VOLUME 2 OF 2 - ZONING

Summary of Comments on P:\Projects\1216-00\BIM\Revit\Families\TITLEBLOCKS\EXTELL Proposal_atwalj.pdf

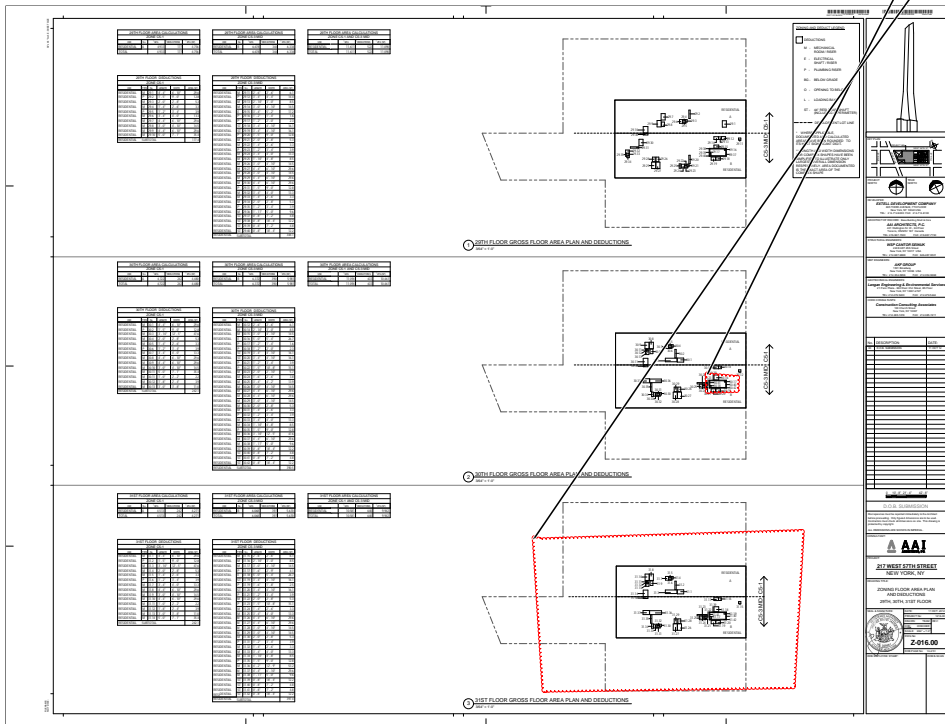
Provide records to verify proof of existing conditions shown on plans provided, approved drawings of existing building floor area zoning calculation to ensure that the proposed zoning analysis does not exceed the maximum permitted

Verification of existing mechanical deductions is required. Sufficient proof must be provided for entire the deducted floor area. (Dimensions) and provide layout of heavy equipment for each floor in consideration to qualify for deductions.

Please clarify deductions taken within stair enclosure. **TYP all floors**
8" for the stair perimeter, not sure what the additional 60+ sq. ft. is for per floor. ARCH/MH dwgs does not indicate any shaft enclosures within stair.

Mech. plan was not provided for this floor. 31st FL.

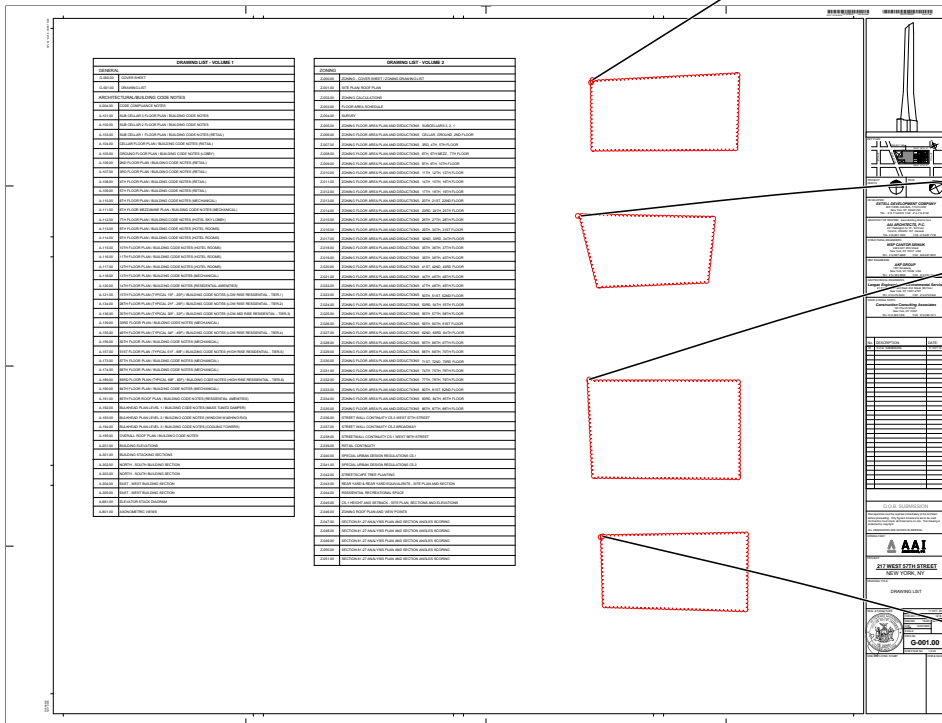
NYC ENERGY CODE 2011
BC 1301 Provide data sheet and state on plans, full compliance with NYC energy code.

List all progress inspections for energy code compliance on drawing.

Supporting documentation: building wall sections fail to detail insulation as continuous and/or cavity insulation to match the location and R value in the energy analysis.

Supporting documentation: door, window and skylight schedules fail to provide columns for u values for each exterior door, window and skylight type. If door, window and skylight types are drawn instead, with specifications included next to the respective drawing, u and SHGC values must appear with the other performance specifications for clarity and ease of contractor take-offs.

Supporting documentation: heating and cooling systems, including controls, are not provided such that they match the systems, equipment and performance criteria in the energy analysis.

Supporting documentation: plans fail to include reflected ceiling plans or lighting layouts on floor plans with fixture types and quantities, lamp wattages and quantities, space areas, sensors and controls to match those in the energy analysis for each room in the building.

Supporting Documentation: Building wall sections fail to label insulation at the roof/ceiling, wall and/or at the foundation, slab-on grade, basement or cellar with R values matching those in the Energy Analysis.

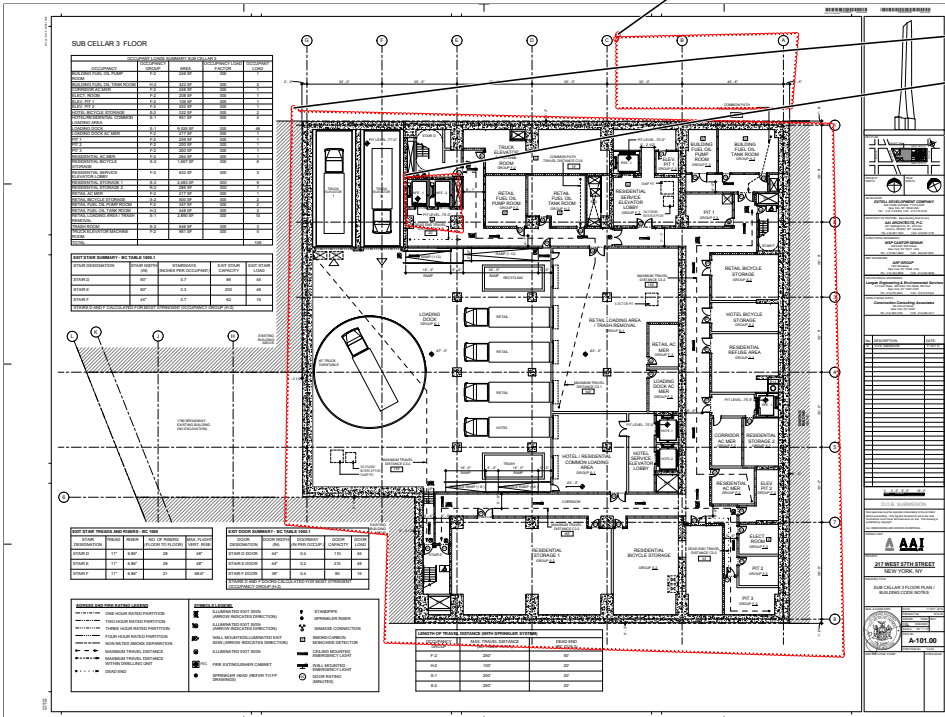
BC 903.2.10 Trash compactor is required for building which contains more than 12 units.

- Indicate trash compactor size, dimensions, & location.
- indicate clearance around trash compactor
 - Indicate sprinkler locations in the trash compactor room.
 - indicate ventilation to fresh air at trash compactor room
 - provide floor drain at trash compactor room
 - Indicate a minimum, 3 hr fire rated enclosure (walls) at trash compactor room i, including 1 1/2hr FPSC rated door.
 - indicate construction details and materials at trash compactor room
 - Indicate sound transmission class (stc) ratings for all trash compactor walls and trash chute walls and disposal; room walls.

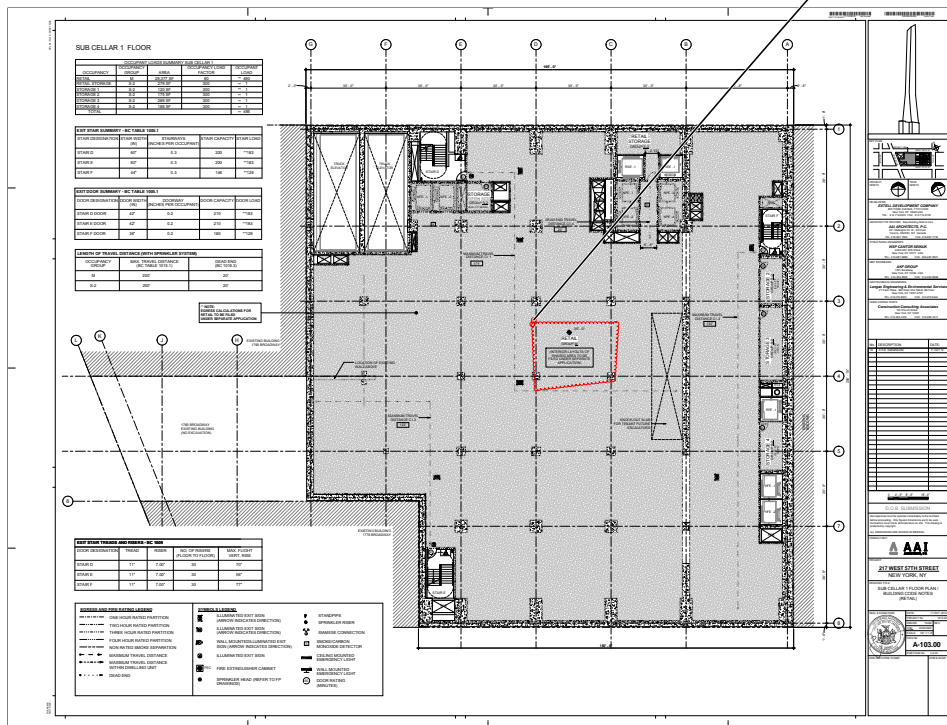
TABLE 403.1 Provide table for plumbing fixtures to comply with table 403.1. Provide calculations within each space, etc. and show layout to verify compliance to BC 1101.2; ICC/ANSI A117.1-2003

All nonresidential facilities to comply with BC 1109.

Water closets

Lavatories
Chow hall

Show all grab-bars including vertical

Required clearance around the water closet to comply with ICC/ANSI 2003 604.3

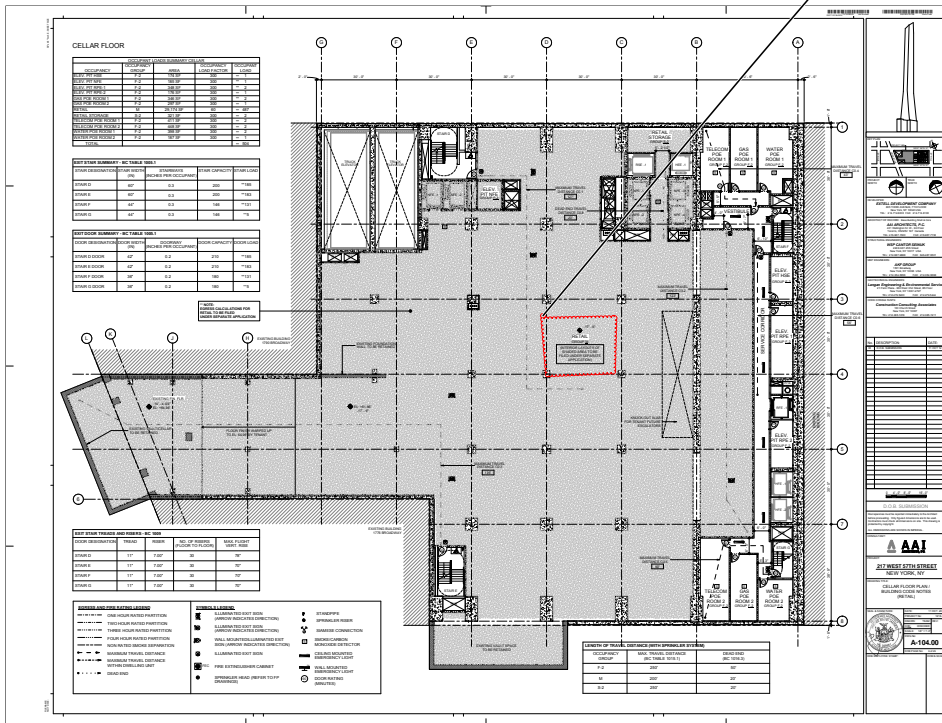
TABLE 403.1 Provide table for plumbing fixtures to comply with table. 403.1. Provide calculations within each space, etc. and show layout to verify compliance to BC 1101.2; ICC/ANSI A117.1-2003

All nonresidential facilities to comply with BC 1109.

Water closets

Lavatories

Show all grab-bars including vertical

Required clearance around the water closet ~~to~~ comply with ICC/ANSI 2003 604.3

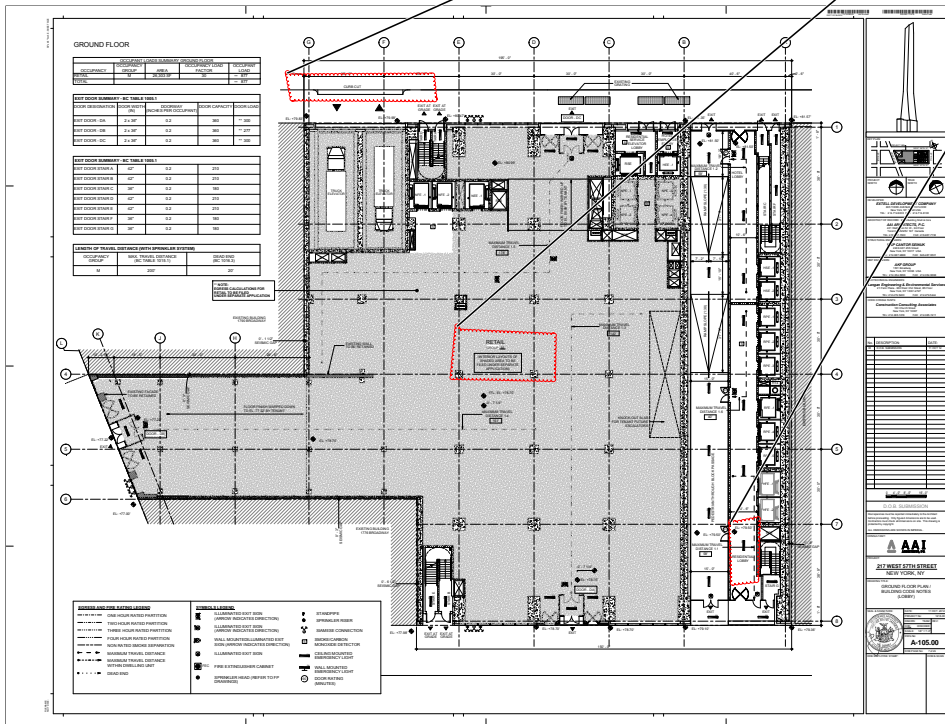
TABLE 403.1 Provide table for plumbing fixtures to comply with table 403.1. Provide calculations within each space, etc. and show layout to verify compliance to BC 1101.2; ICC/ANSI A117.1-2003

All nonresidential facilities to comply with BC 1109.

Water closets

Lavatories

Show all grab-bars including vertical

Required clearance around the water closet to comply with ICC/ANSI 2003 604.3

Provide note to verify compliance with BC 1008.4.1; 1008.4.2; 1008.4.3; 1008.4.4

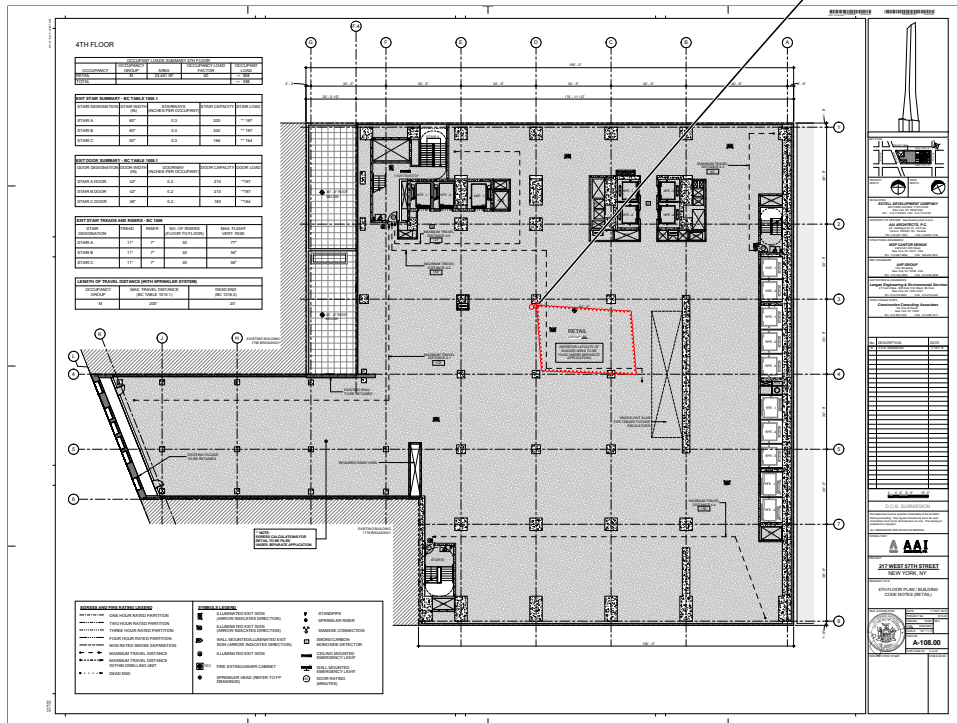
TABLE 403.1 Provide table for plumbing fixtures to comply with table 403.1. Provide calculations within each space, etc. and show layout to verify compliance to BC 1101.2; ICC/ANSI A117.1-2003

All nonresidential facilities to comply with BC 1109.

Water closets

Lavatories
Chow hall

Show all grab-bars including vertical

Required clearance around the water closet to comply with ICC/ANSI 2003 604.3

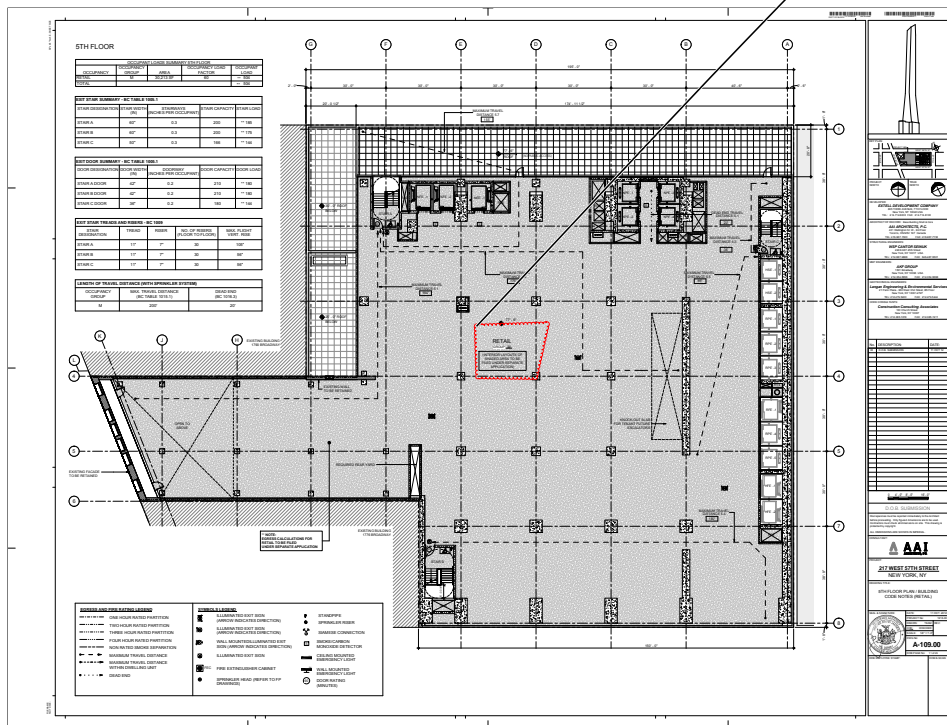
TABLE 403.1 Provide table for plumbing fixtures to comply with table. 403.1. Provide calculations within each space, etc. and show layout to verify compliance to BC 1101.2; ICC/ANSI A117.1-2003

All nonresidential facilities to comply with BC 1109.

Water closets

Lavatories

Show all grab-bars including vertical

Required clearance around the water closet to comply with ICC/ANSI 2003 604.3

Provide exit lighting and directional signs (lighting) & (egress) as per BC 1006, BC 1011, BC 1026 (both EG and Construction plans)

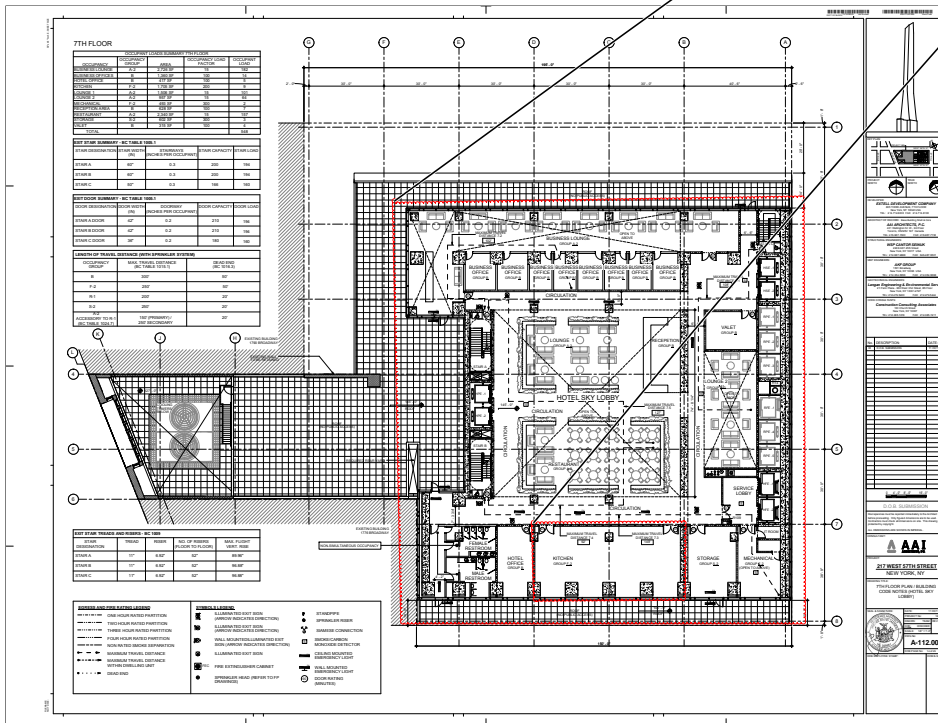
BC 903.2.12.2 Commercial cooking operations. An automatic sprinkler system shall not be installed in a commercial kitchen exhaust hood and duct system. Fire extinguishing systems shall be installed in commercial cooking systems in accordance with Section 904.11.

BC 904.2.1 Hood system suppression. Each required commercial kitchen exhaust hood and duct system required by the *New York City Fire Code* or the *New York City Mechanical Code* to have a Type I hood shall be protected with an approved automatic fire-extinguishing system installed in accordance with this code.

Kitchen shall also comply with MC 506, 507, and 508; PC 802.1.7 and 1003.3.1. Please verify on MH/PL plans.

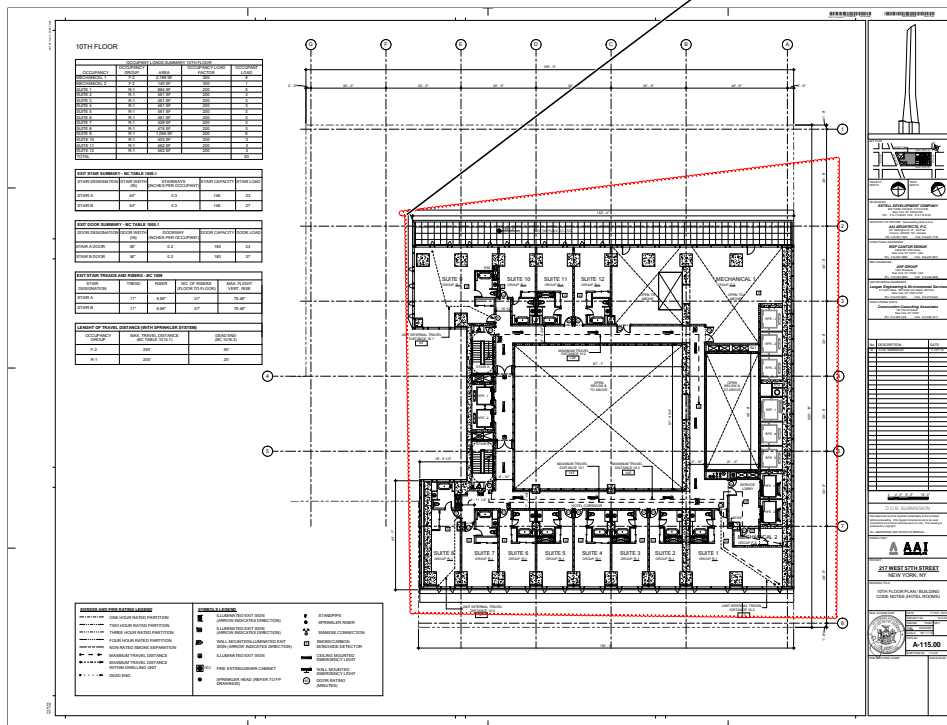
- Provide note describing stairway door operation and stairway communications system as per BC 403.12 04-16-13
- Provide note describing smoke proof exit enclosures for compliance with BC 403.13. 04-16-13
- Provide note describing impact-resistant stairs enclosures as per BC 403.15 04-16-13
- Indicate photo luminescent exit path markings as per BC 403.16. 04-16-13
- Provide exit lighting and directional signs (lighting) & (egress) as per BC 1006, BC 1011, BC 1026 (both EG and Construction plans) 04-16-13

- Group R-1 occupancies shall be provided with accessible features in accordance with Sections 1107.6.1.1 through 1107.6.1.3.
- Show all grab-bars including vertical as per P102.8.3.1, (TYP)
- Provide note within each accessible unit or sleeping unit shall comply with the 2008 code and Chapter 1 through Chapter 10 of ICC A117.1. (TYP) 04-16-13

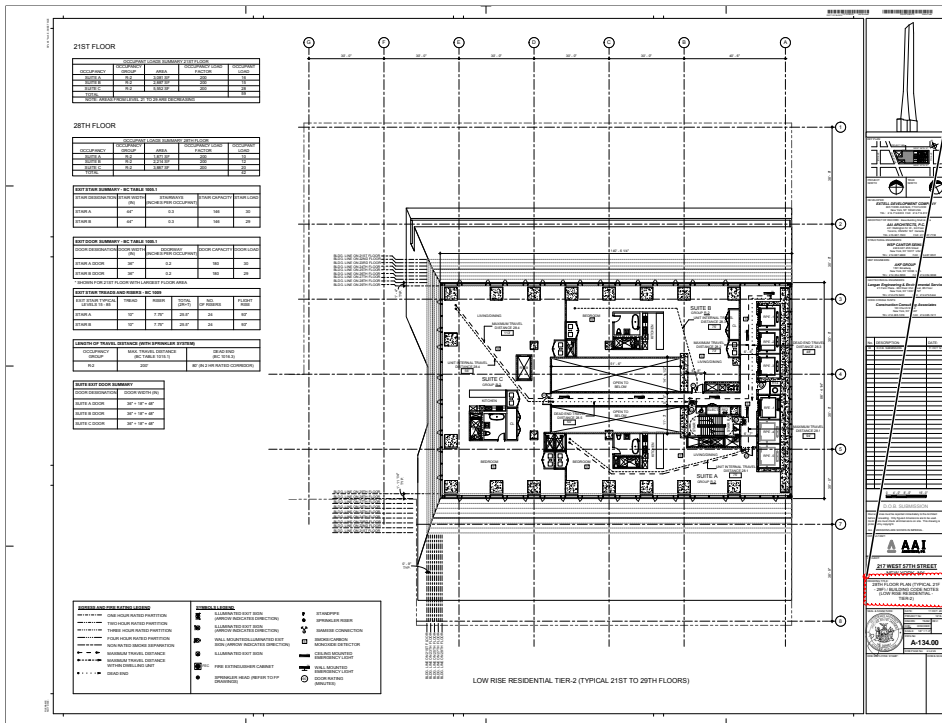
Author: dtitus Subject: Polygon Date: 1/7/2013 9:31:18 AM
The common path of egress travel shall not exceed 125 feet as per BC 1013.3. The maximum length of exit access travel, measured from the most remote point within a story/space to the entrance to an exit along the natural and unobstructed path of egress travel, shall not exceed the distances given in BC Table 1015.1.

Author: dtitus Subject: Polygon Date: 1/7/2013 9:30:14 AM
BC 908.7.1.2 Provide notes to indicate compliance for carbon monoxide detectors.
Indicate location of smoke/ carbon monoxide detectors. (TYP.)

Author: dtitus Subject: Polygon Date: 1/4/2013 10:06:27 AM
Provide refuse chute details: [2 hr fr walls & roof] and compliance with BC 1213.3 and BC 707.13
Refuse storage room to comply with BC 1213.1
Provide proper enclosure and details
Provide UL # for system or fire hopper doors
Compliance with BC 1101.2;

Author: dtitus Subject: Polygon Date: 1/4/2013 10:41:39 AM
Provide note describing stairway door operation and stairway communications system as per BC 403.12
Provide note describing smoke proof exit enclosures for compliance with BC 403.13.
Provide note describing impact-resistant stairs enclosures as per BC 403.15
Provide exit lighting and directional signs (lighting) & (egress) as per BC 1006, BC 1011, BC 1026 (both EG and Construction plans)

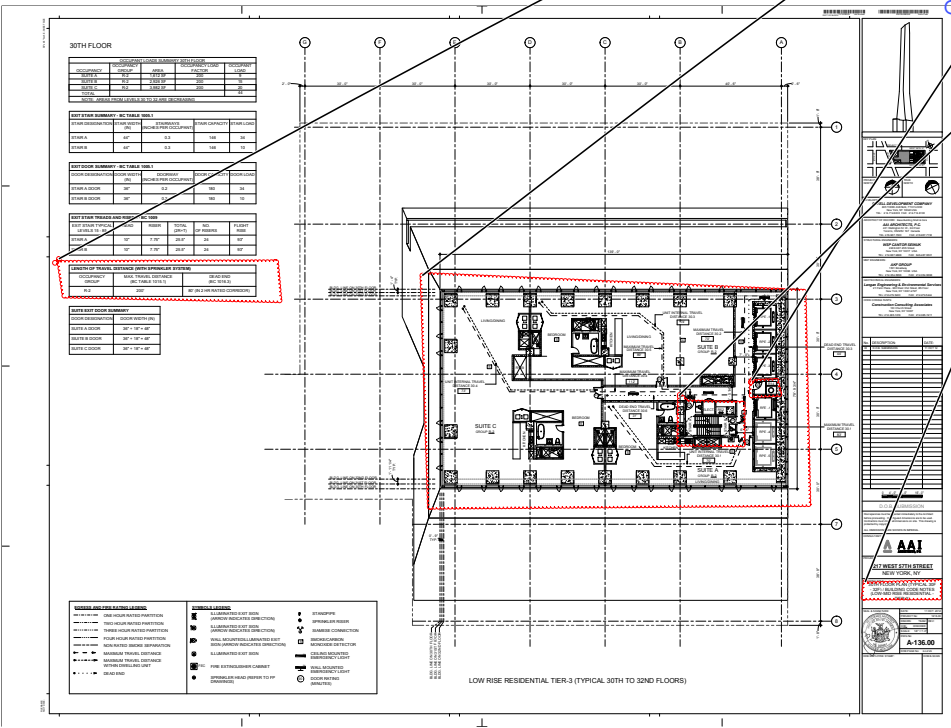
Author: dtitus Subject: Polygon Date: 1/4/2013 10:05:14 AM
Please indicate as Typ. 30-32nd Floor Plans

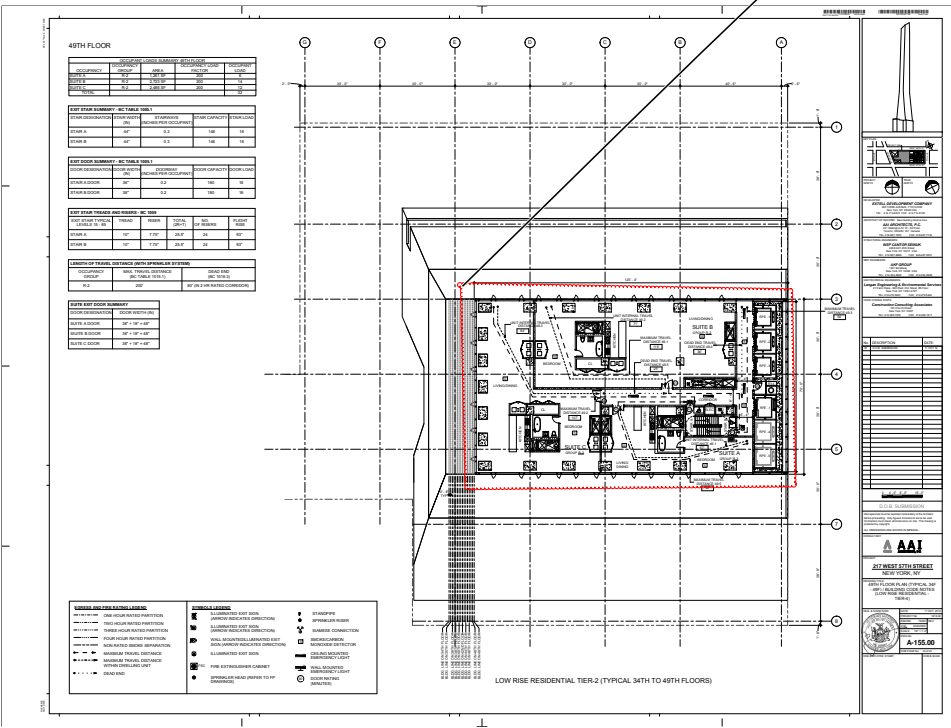
BC 1101.1, 1101.2, and
ICC/ANSI A117.1-2003 Verify compliance with accessibility as per BC 1101
Primary access- 1105
Doors & maneuvering clearances-1107.2.1
Residential bathrooms – 1107/ Appendix P
Residential kitchens – 1107.
Show all grab-bars including vertical as per P102.8.3.1,
Walk-in closets
Access to W/D within units
TYP. all R-2 floors

Author: dtitus Subject: Polygon Date: 1/2/2013 11:57:13 AM
Propose mechanical room is not permitted to open into stair enclosure as per BC1019.1.2
